MATCH LINE - SEE SHEET C-11
DRAINAGE, UTILITIES AND GRADING PLAN
MONTECELLO MARKETPLACE
WILLIAMSBURG, VIRGINIA
FOR
MONTECELLO MARKETPLACE ASSOCIATES L.L.C.
SHEET C10 OF
DISK LAYOUT13.DWG
PROJ. NO. 96046-07
DWG. 5925C W

**Subject:** SP-72-98 Monticello Marketplace - Site Plan Revision for Retaining Wall, etc.

ENVIRONMENTAL DIVISION REVIEW COMMENTS  
MONTICELLO MARKETPLACE  
PLAN NO. SP-72-98 *PTM/DEC*  
June 17, 1998

SHEET C13 OF  
DISK LAYOUT13.DWG  
PROJ. NO. 96046-07  
DWG. 5925C W

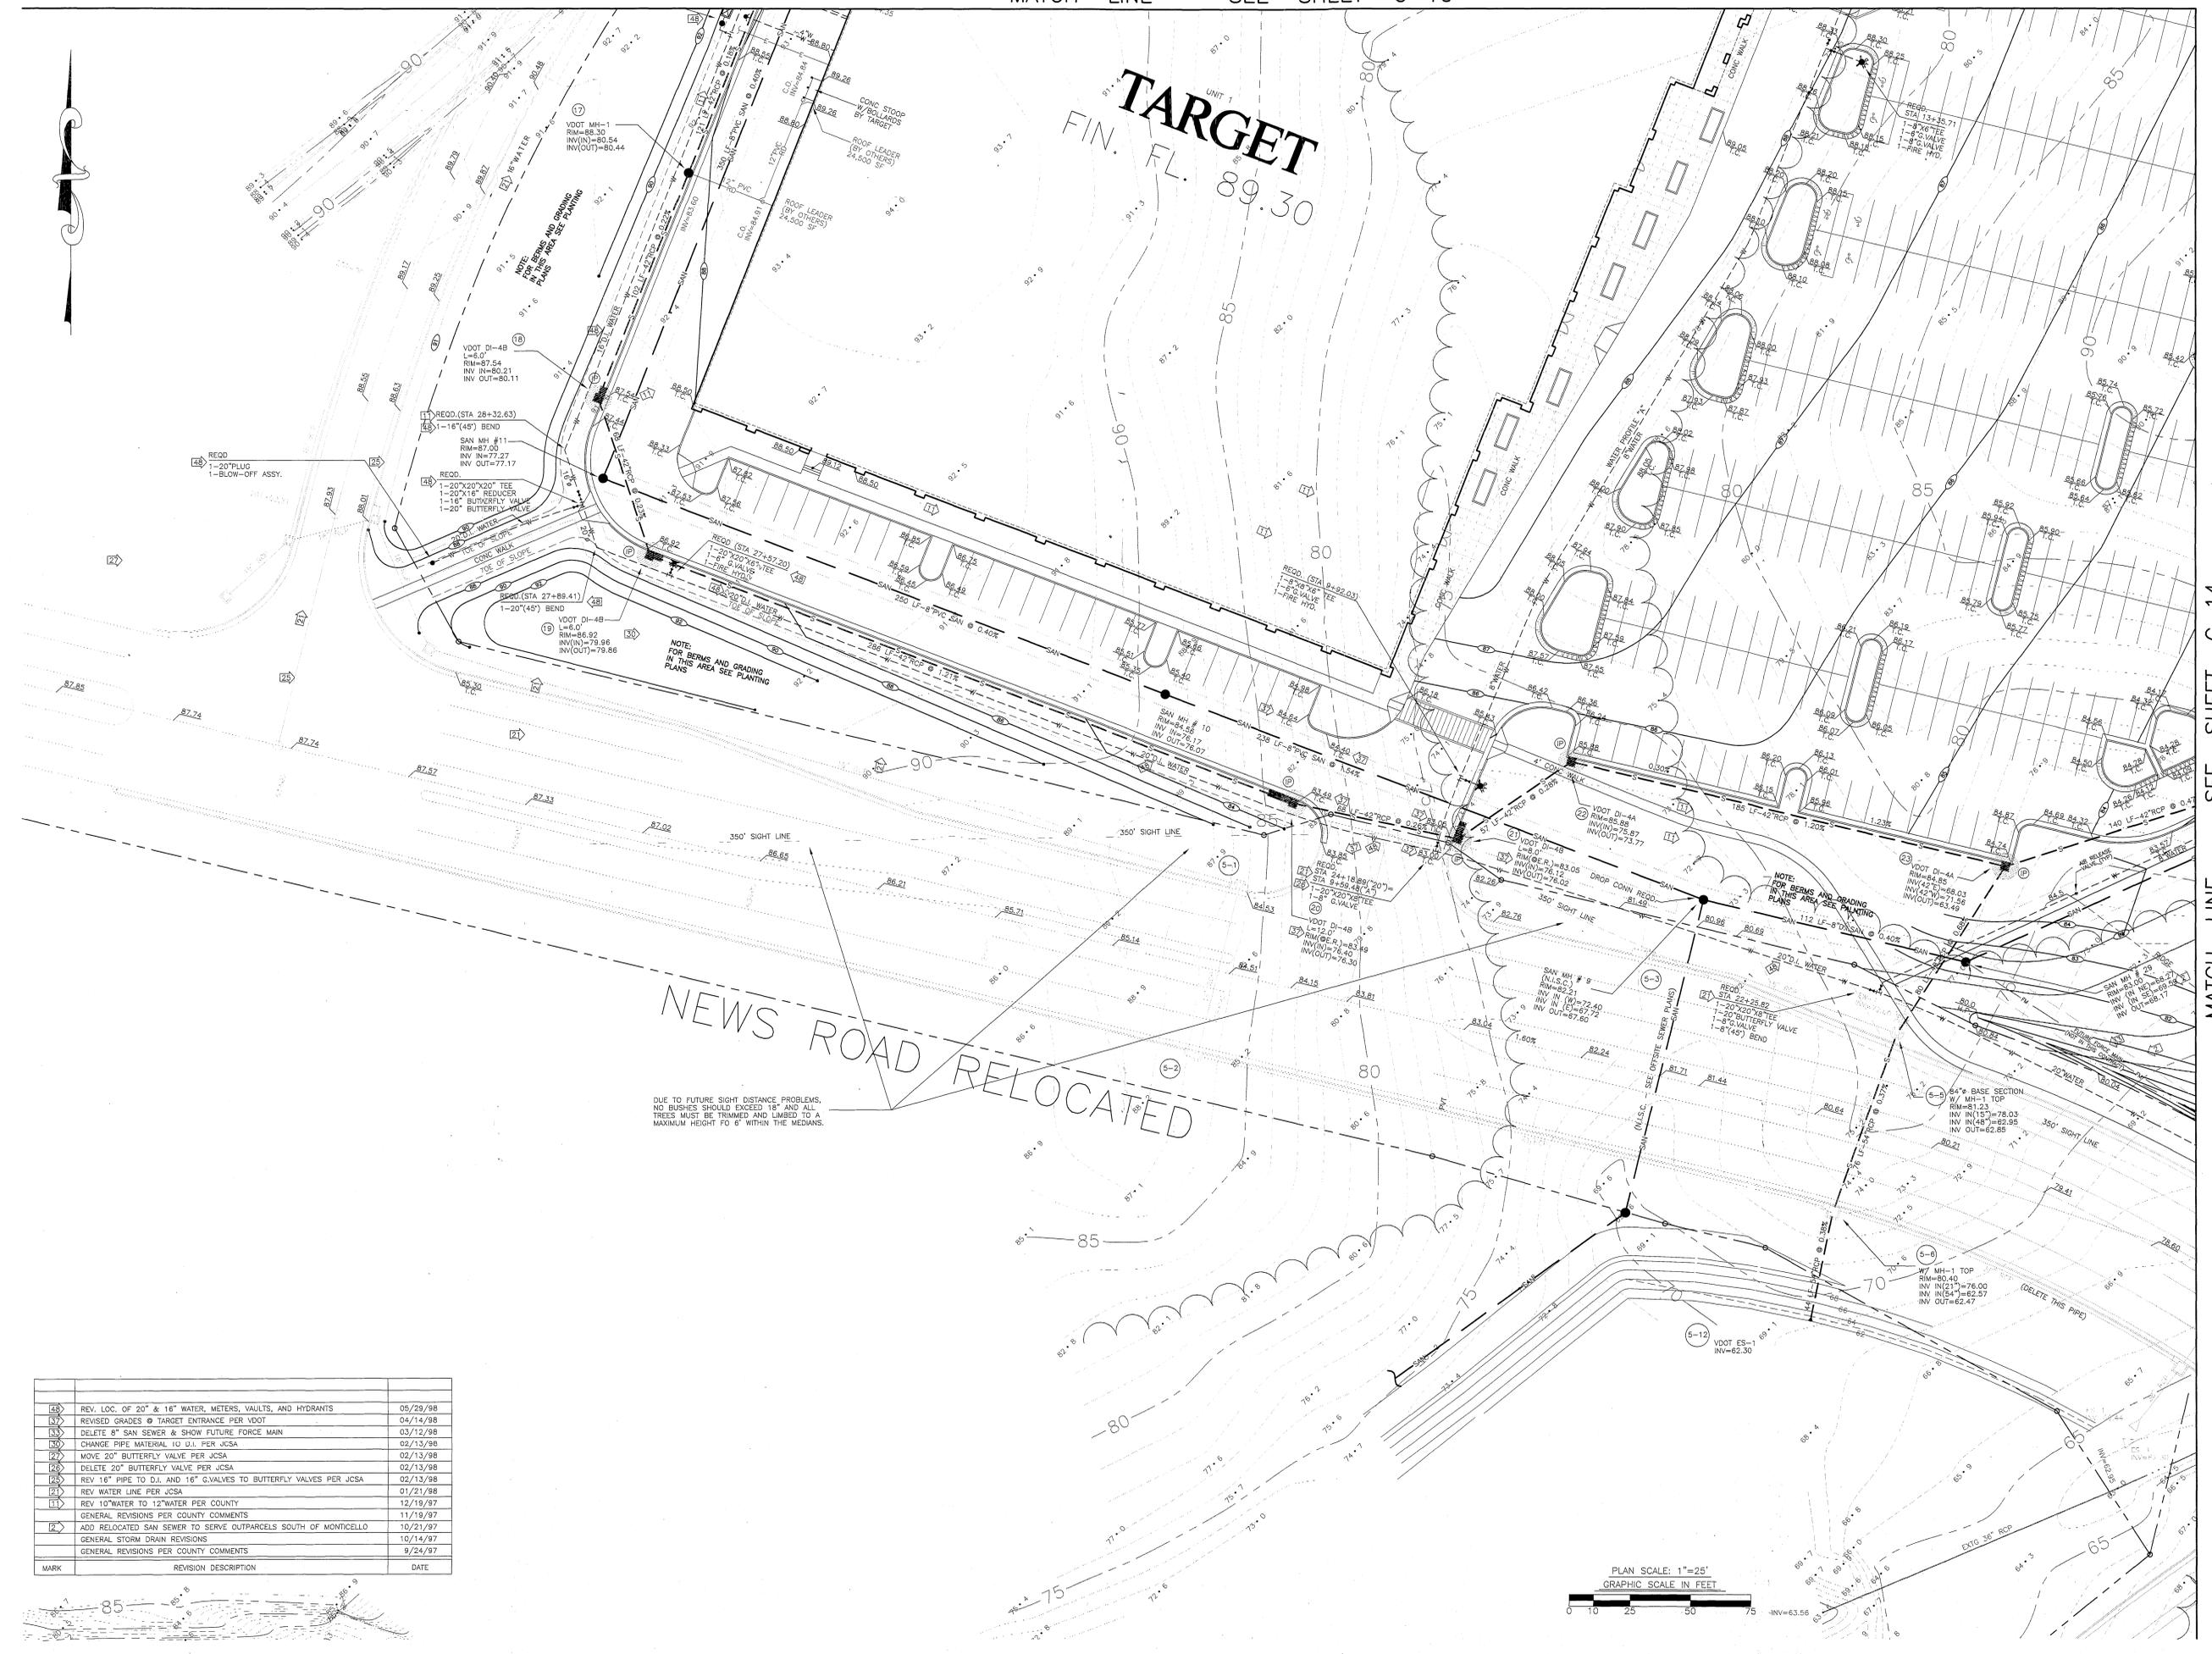
11. Slopes in excess of 3:1 are being created along the southern edge of the project where it meets Relocated News Road and Monticello Road. These slopes must be reduced to 3:1 or flatter or special treatment specified to ensure stabilization of these slopes. These slopes appear on sheet C-13.

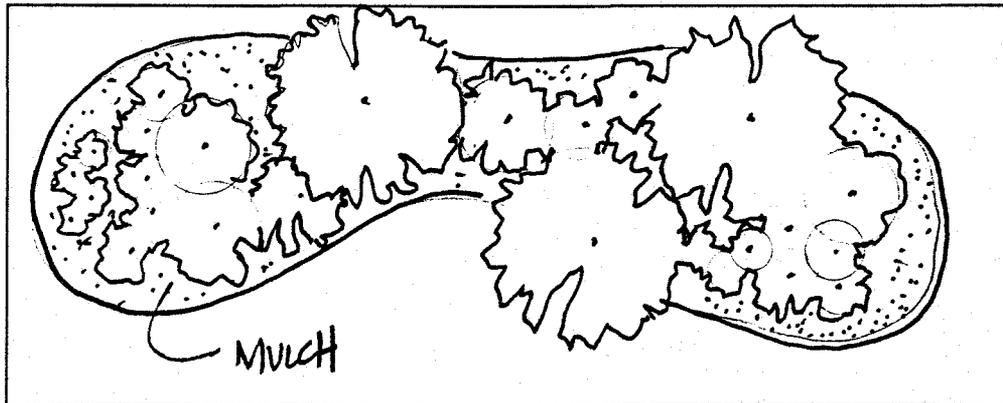
*Continue the roof line across the front of the grill and café. Right now it sort of sticks out like a sore thumb.*

*The windows of the café do not match well with the other elements of the center. We suggest using panes and window sills to give the windows a more "classic" look.*

*Would it be possible to continue the roofline across the front of Target. At the very least plant some larger trees in front to help "soften" the mass of brick.*

SHEET C14 OF  
DISK LAYOUT13.DWG  
PROJ. NO. 96046-07  
DWG. 5925C W

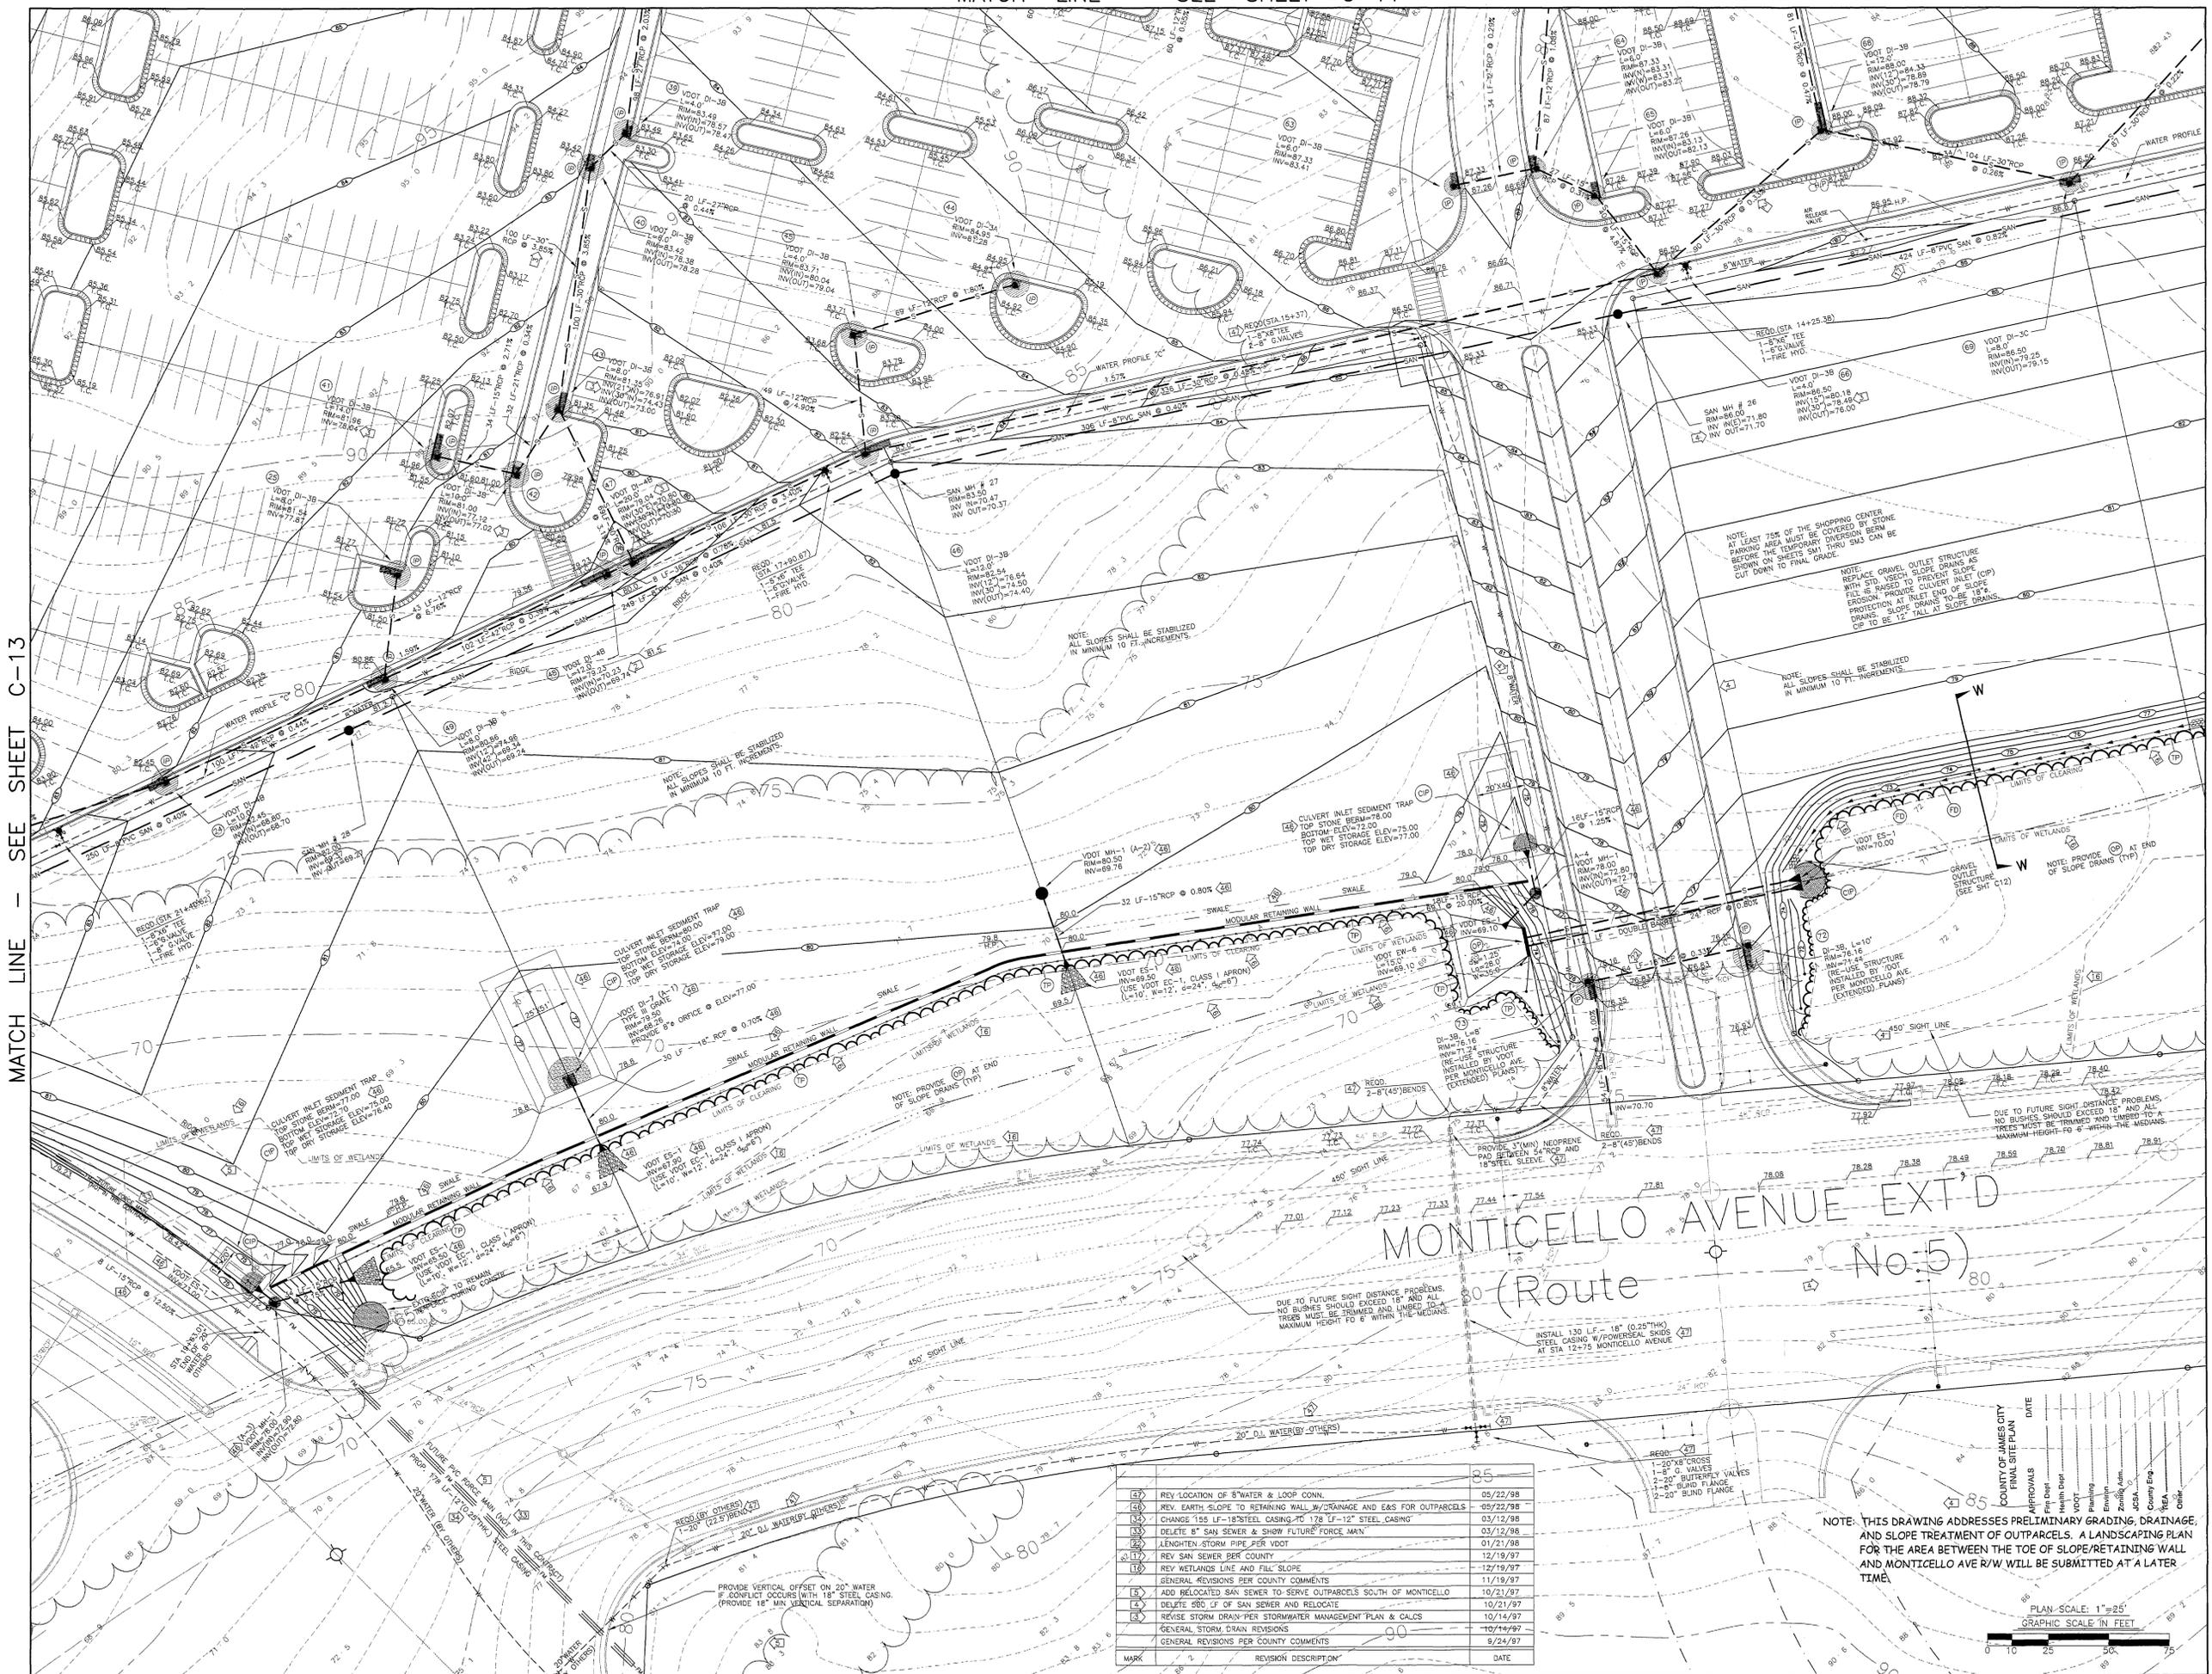
3. Provide the appropriate method of stabilization for all proposed drainage swales or conveyance channels.
4. On plan sheet # C-14 there is a reference to a modular retaining wall, please provide the following:

- A. Provide a note on plan sheet C-14 which states that the modular retaining wall will be built in accordance with the manufacturers specifications and recommendations and will be in compliance with all applicable State and Local requirements.

- B. Provide the manufacturers specifications and recommendations for the installation of the proposed retaining wall, including this projects design parameters.

6. The Sediment trap shown on plan sheet #C-14 located on the property line dividing two of the out parcels should be relocated so that the proposed "Chick-Fil-A" outparcel construction will not eliminate the trap.

13. Provide temporary slope drains at the gravel outlet structures shown on sheet C-14 to convey

14. Delete the silt fence shown on the far right side of sheet C-14 as it appears to serve no purpose.
15. The erosion control plan for this site is inadequate. The only control measures shown are inlet protection and fill diversions, both of which are functional only after fill has been placed (and only with a stable outlet structure), and all pipe has been laid. Provide an erosion control plan to adequately protect the site beginning with the clearing stage.

1. As shown on sheet C-14 of the plan, the amount of fill and grading is excessive and unacceptable. The final grade of elevation 68 should be moved toward the parking lot ("pulled away" from wetland area) a minimum of 35 feet. The objective is to preserve a substantial buffer of trees and open space between the parking area for the outparcels and the wetland area.
2. The use of fly-ash for fill material is **not** acceptable.
3. There shall be no clearing allowed in the wetland areas or adjacent buffer areas.
4. Please refer to the attached Code Compliance comments dated June 30, 1997.

12. Requested note has been added to Sheet C-14.
13. Included in previously submitted Stormwater Management Plan sheets.
14. Silt fence deleted as suggested.
15. See revised Stormwater Management Plan.
16. See revised Stormwater Management Plan.
17. If required by VDOT, owner will provide an easement from structure on News Road to the following structure. At this point no such request has been made.
18. Confirmation of sediment trap design has previously been provided.
19. Inlet calculations have been previously provided with Stormwater Management package.
20. Issue resolved with Stormwater Management Plan.

3. Swales are graded at less than 1%. Temporary seeding has been provided for in erosion control notes.
4. Items are addressed on retaining wall drawings by Schnable, and are attached.
5. Sequence of construction has been included in the Erosion Control Narrative on Sheet C-15.
6. Sediment trap has been shifted.
